ARKANSAS NUCLEAR ONE - UNIT 1

IMPROVED TECHNICAL SPECIFICATIONS SUBMITTAL

VOLUME 3 OF 7

January 28, 2000

Table 3.3.11-1

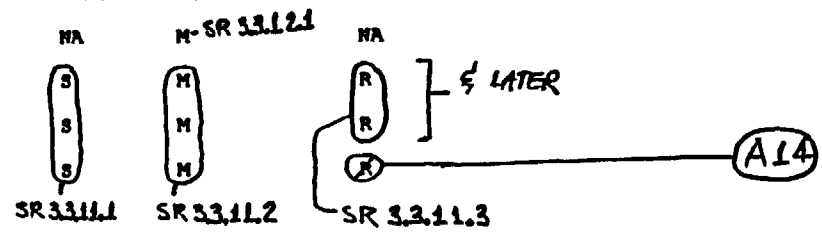
- a. Manual
- # 1.b b. SG Low Level, SGA or B
- # 1.C c. Low Pressure SGA or B
- # 1. d d. Loss of both MFW Pumps and PWR > 100
